AIR RESOURCES BOARD

Final Statement of Reasons for Rulemaking,

Including Summary of Comments and Agency Response

OF THE LOW CARBON FUEL STANDARD

Figure 8. Change in Arable Land Plus Permanent Crops: 2004–2006 to 2010–2012

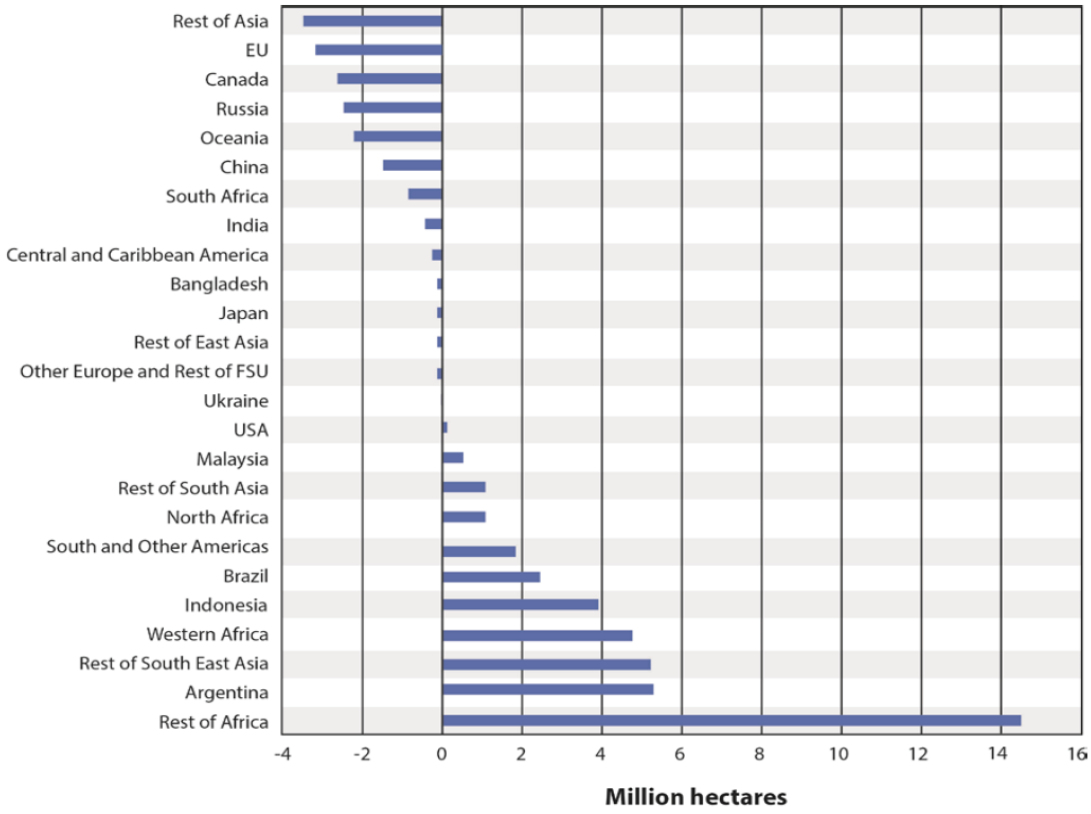
Figure 8 from Babcock & Iqbal is embedded below. Note that many countries and regions for which CARB's latest GTAP analysis predicts extensive change from forest and grassland to crops actually showed cropland losses or no change. This includes Canada, EU, Japan, China, India, Russia, the U.S., and Oceania. Further, the amount of corn ethanol-induced conversion of

forest and grassland in the U.S. predicted by CARB's GTAP model is two to four times larger than the actual extensive land use change in the U.S. driven by ***all factors in aggregate***.

As stated in the Babcock & Iqbal paper, CARB should not presume that higher crop prices have caused conversion of forest and grassland to crops in countries and regions where cropland has actually decreased over the past 10 years. Thus, we believe CARB should calibrate its GTAP model to disallow forest and grassland conversion in AEZs and regions for which empirical data show forest or grassland expansion and/or cropland contraction. This can be easily accomplished by excluding GTAP predicted land conversions for the countries in Figure 8 of Babcock & Iqbal that show negative extensive change (i.e., loss of cropland). A more detailed method for accomplishing this calibration is available in comments submitted to CARB by Air Improvement Resource on Dec. 4, 2014.[9]

For the countries in Figure 8 that *do* show extensive land use change over the past 10 years, CARB can continue to rely on GTAP predictions, but should also conduct more intensive research to better understand the precipitating causes of land conversions at the extensive margin in those countries. For example, while Sub-Saharan Africa (excluding South Africa) shows significant extensive change over the past decade, it is likely unrelated to biofuels expansion in the U.S. According to Babcock & Iqbal, "The extent to which extensive expansion in African countries was caused by high world prices is likely small for the simple reason that higher world prices were not transmitted to growers in many African countries."[10]
